Chiquita Lock RAI#2 - Supporting Document July 10, 2017. Response to DEP Phone Conversation June 30, 2017

On June 30, 2017 the City of Cape Coral participated in a phone conference with Department of Environmental Protection staff in its Fort Myers and Tallahassee offices to discuss several items regarding the City permit application for removal of the Chiquita boat lock.

Figure 1. Locations of sites used for water quality comparison.

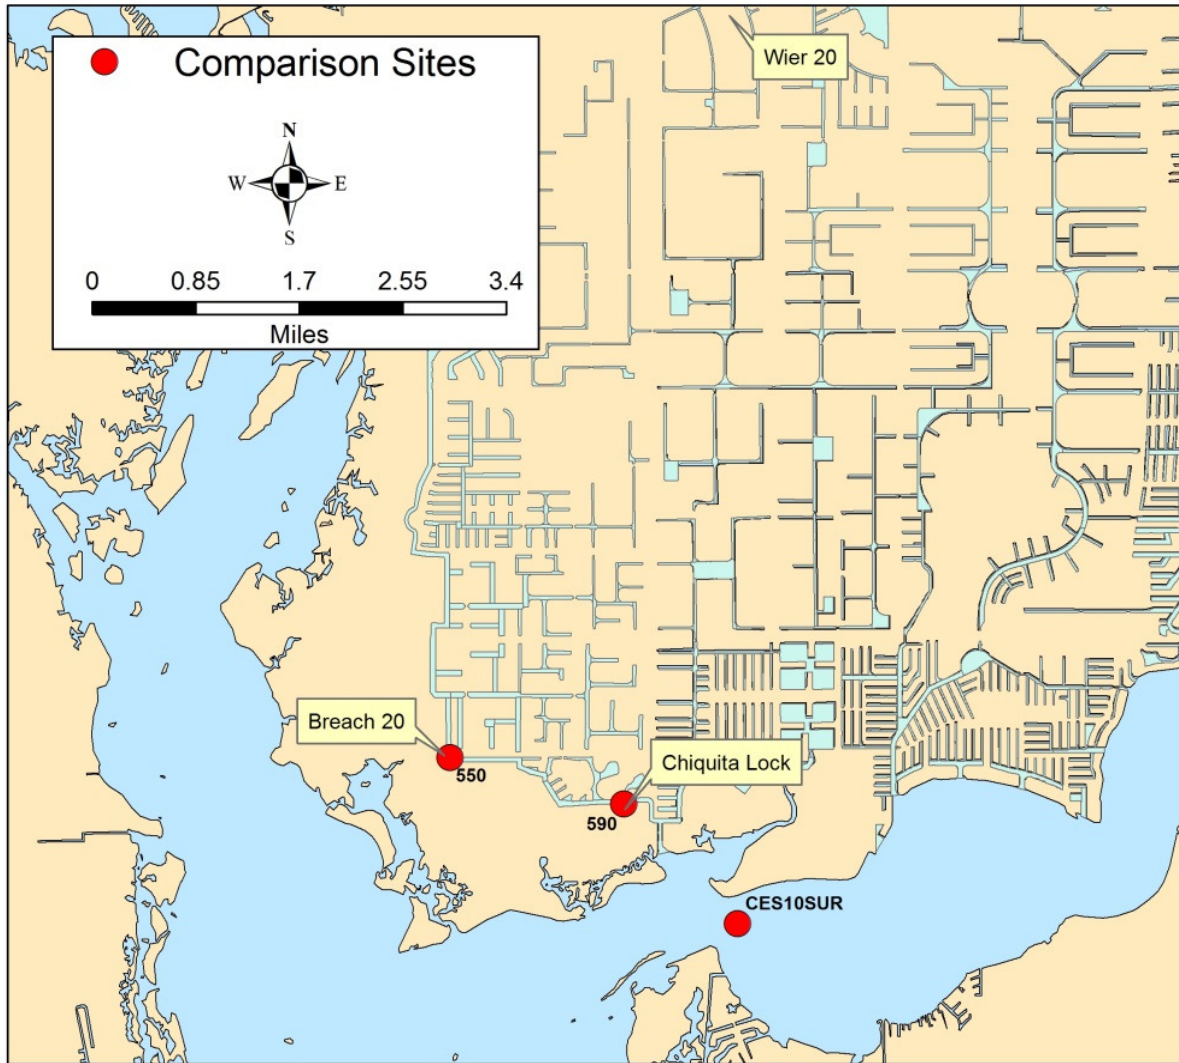
The current lock operations likely contribute to the observed water quality within the canal system and the adjacent Caloosahatchee River. As presented previously, the City of Cape Coral conducts monthly monitoring throughout its waters. In the canal system above the Chiquita Lock two sites represent the water that would discharge through the Lock and Breach 20, Stations 590 and 550, respectively (Figure 1). Many organizations monitor the Caloosahatchee River, including various state agencies and the City of Fort Myers. A location monitored by Fort Myers was chosen to represent the river near the mouth of the canal system, station CES10SUR (Figure 1).

For each of the stations, time series of total nitrogen concentrations are shown in Figure 2. Mean TN values for the three sites are 0.67 mg/L, 0.69 mg/L, and 0.68 mg/L for stations 550, 590, and CES10SUR, respectively. Median TN values are 0.70 mg/L, 0.70 mg/L, and 0.63 mg/L, respectively. The concentrations at the two canal sites are very similar to those at the long term site in the Caloosahatchee River near the Lock. These results lead to the conclusion that the discharges from the South Spreader Canal in the "lock removed" condition would have little effect on the nitrogen concentrations in the river.
